PROCESS CHANGE NOTIFICATION

PCN0902

ADDITIONAL ASSEMBLY SOURCE AND BILL OF MATERIAL CHANGE FOR ALTERA FLIP CHIP PRODUCTS

Figure 1. Date-Code Marking

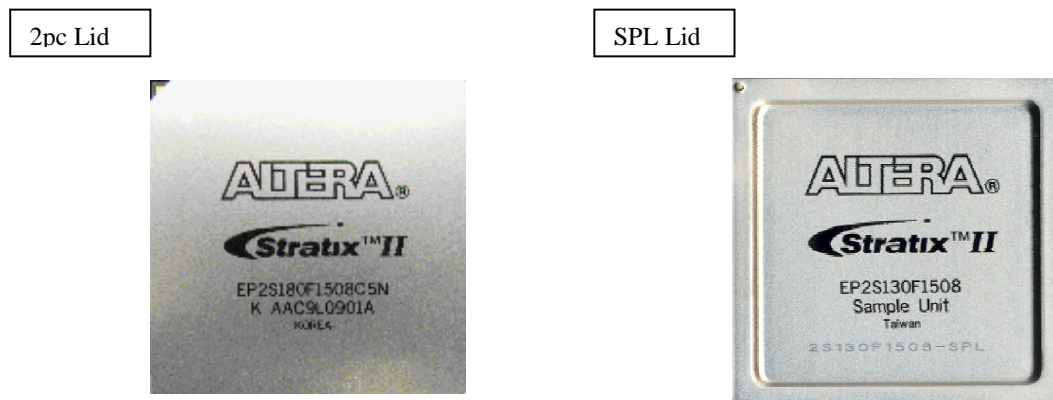
This change will be implemented in July 2009. Customers may receive products with this change beginning with a date-code marking of 0925 or later on the top of the package. See Figure 1. The 0925 date-code marking indicates the earliest date that the new material may be used for any of the affected devices. However, initial samples may have an earlier date-code marking.
